# Okahu & Puhoi Viaducts Deck System Review

# Okahu & Puhoi Viaducts Deck System Review Temporary Reinforcement Trusses

27 March 2020

**Photo 2:** Typical centre precast deck panels

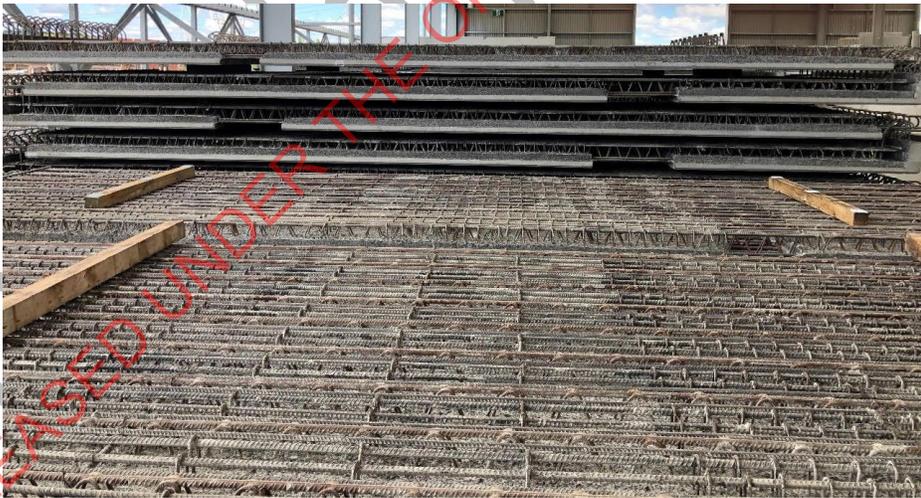
Additionally, the precast panels appear not to have been cambered and are flat. This can be seen in **Photo 2** and **Photo 3** above. MM calculate by simple elastic theory that the Okahu centre panel have midspan deflections of over 30mm occurring during the topping pour. This will cause 'ponding' of the topping concrete and exacerbate both the deflections and the compression of the TRT top chords.
